STAFF RECOMMENDATION
1000 Paris Avenue
July 17, 2019

Application: Violation; New Construction—Addition
District: Waverly-Belmont Neighborhood Conservation Zoning Overlay
Council District: 07
Base Zoning: R8
Map and Parcel Number: 11801022900
Applicant: Larry Swoopes, Owner
Project Lead: Sean Alexander, sean.alexander@nashville.gov

Drawings Submitted for July 2019 MHZC Review

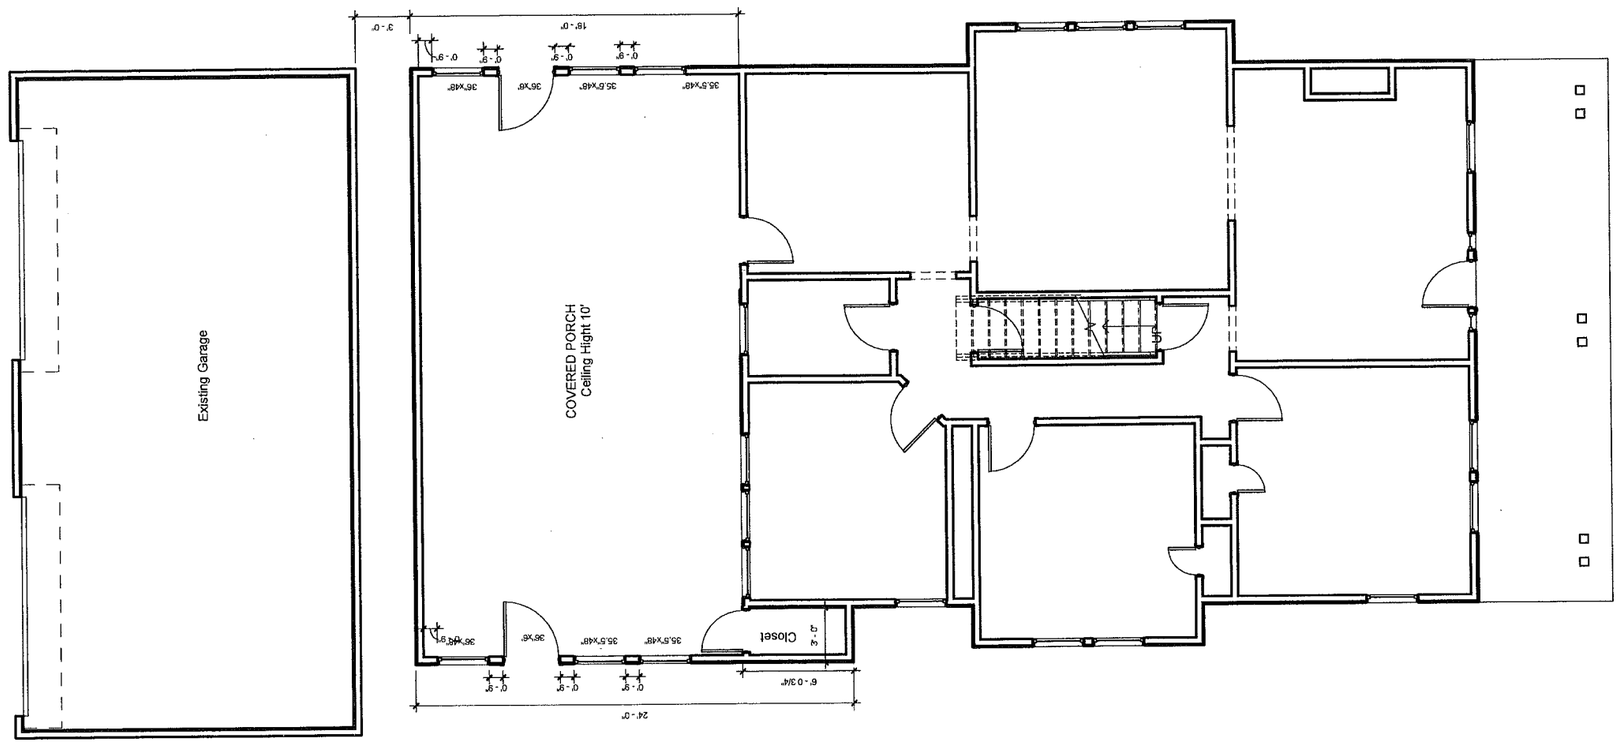
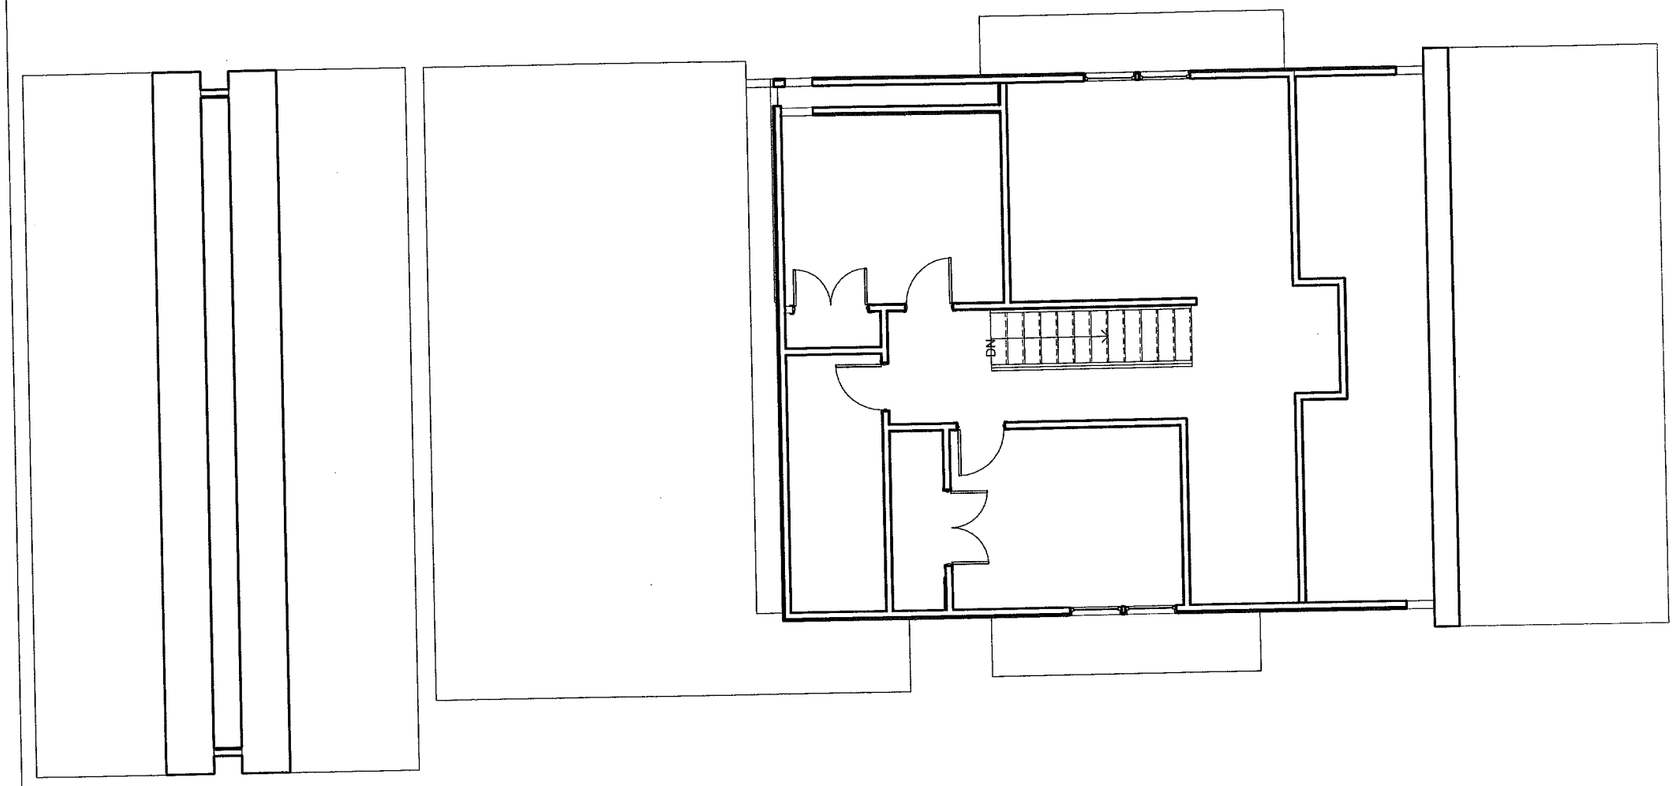
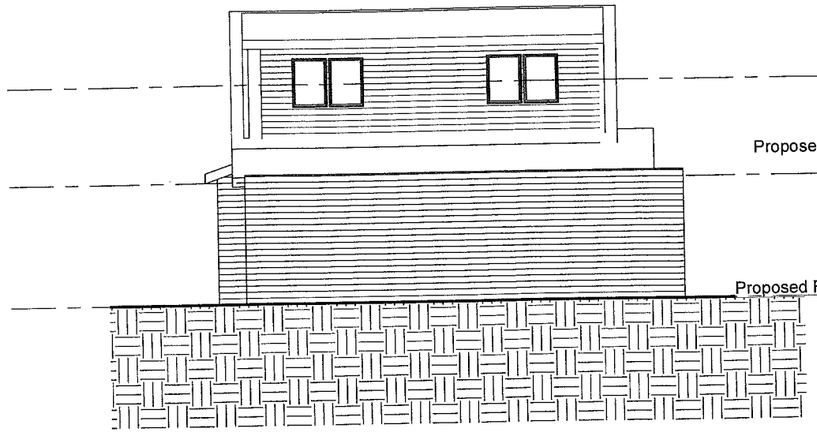
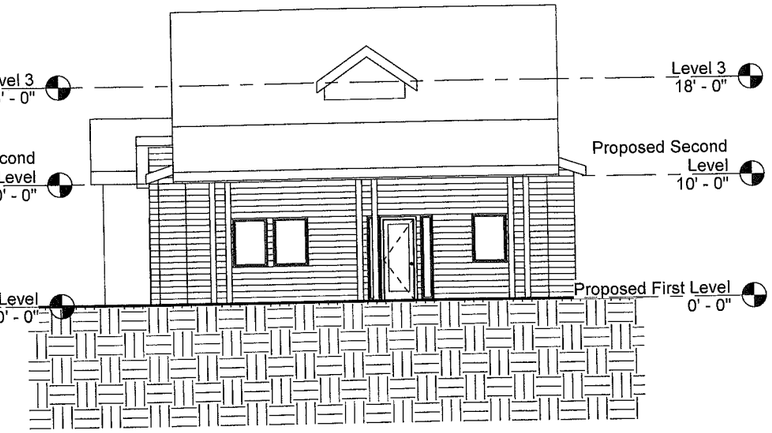
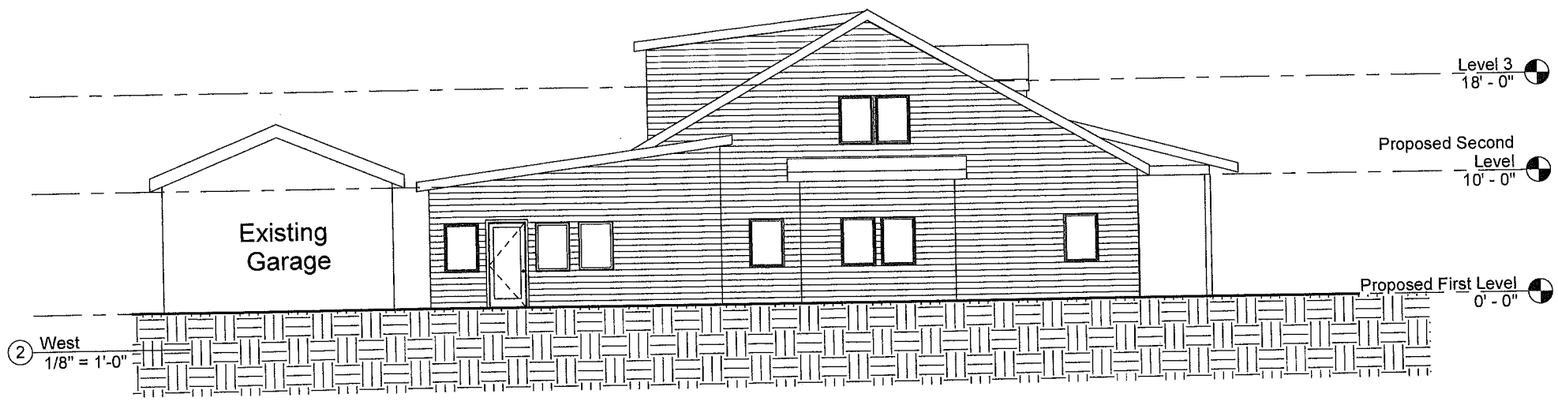
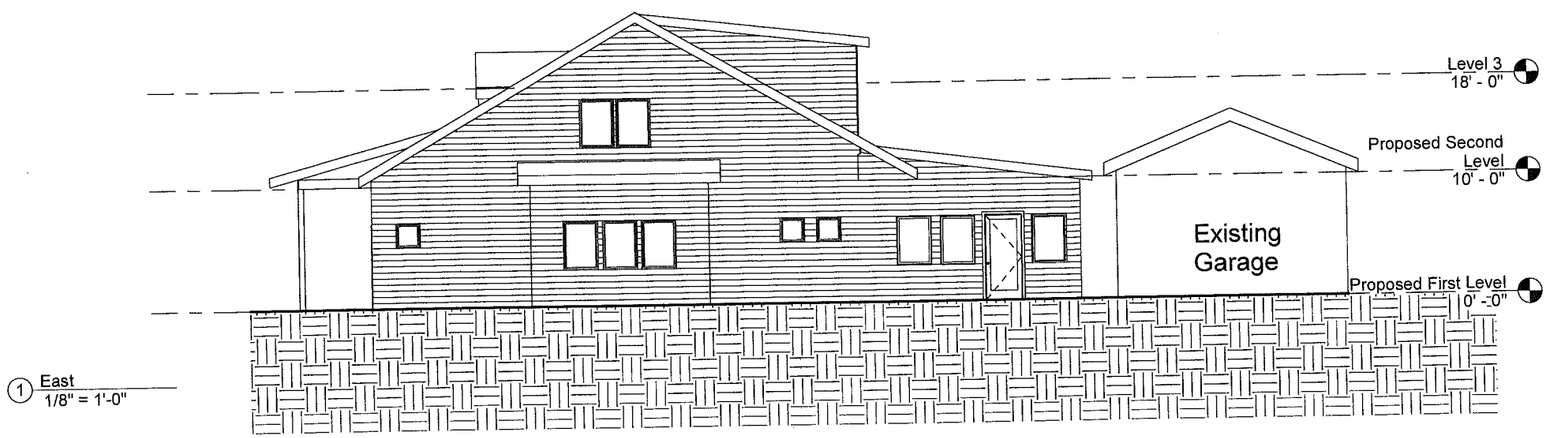
Location & Removability: The addition attaches to house with a gable roof tying into the rear wall and the right side stepped in from the original wall of the house by six inches (6”). Under section IV.A.1.b. of the design guidelines, additions are typically required to step in one foot (1’) from the sides of an historic house. While the addition does not step in a full one foot (1’) from the side of the house, staff finds that the location would be appropriate if the scale were minimal and the material were differentiated from the primary cladding on the house. As proposed, however, staff finds that the addition does not meet section IV.A.1.b. of the design guidelines.

Height & Scale: The addition will tie into the rear wall of the house, ten feet (10’) below the roof ridge. The sides of the addition will be stepped in six inches (6”) from the right side of the building and approximately twelve feet (12’) on the left. Normally, an addition of this size would be appropriate. In this instance, however, staff finds that the separation between the house and outbuilding is insufficient, and at only two feet (2’) the eaves are forced to overlapping each other. The resulting appearance is as if the addition connects the historic house and the outbuilding into a single structure. In total, the resulting construction has a depth greater than one hundred feet (100’), which is significantly greater than any historic house in the neighborhood.

Staff finds that while the height and width of the proposed addition are appropriate but that the depth and the resulting massing and open space of the partially-constructed addition with the recently constructed outbuilding is not compatible with the surrounding historic context and therefore does not meet sections section IV.B and III.B.1 of the design guidelines for new construction.

Plans submitted by the applicant after-the-fact are not accurate, so they were not relied on to determine height and scale.

Setback & Rhythm of Spacing: The rear corners of the addition are separated from the outbuilding by only two feet (2’) and the eaves and roof of the addition overlap the roof of the outbuilding. Under section III.C.2. and III.H.6.a. of the design guidelines, outbuildings should typically be located at the rear of the lot close to the alley. The Commission has determined that, as italicized in the design guidelines as section III.H.6.d., an outbuilding should be behind the principal building with twenty feet (20’) of separation between the house and the outbuilding.

Staff finds that with the addition leaving only two feet (2’) of separation between the principal building and the outbuilding, with the eaves of the addition overlapping those of the outbuilding, the separation between the two structures is not appropriate.

Staff finds that the addition as it is constructed does not meet sections III.C.2. and III.H.6.a., and III.H.6.d. of the design guidelines.

Plans submitted by the applicant after-the-fact are not accurate, so they were not relied on to determine other materials.

Plans submitted by the applicant after-the-fact are not accurate, so they were not relied on to determine roof form or pitch.

Recommendation: Staff recommends disapproval of the rear addition, finding that the addition as it is constructed does not meet the design guidelines for the Waverly-Belmont Neighborhood Conservation Zoning Overlay, sections IV.A.1.b. (Location), III.B.1 and IV.B (Scale), III.C.2. and III.H.6.a., and III.H.6.d. (Setback & Rhythm of Spacing). Additionally, staff recommends that the addition is removed within sixty (60) days.
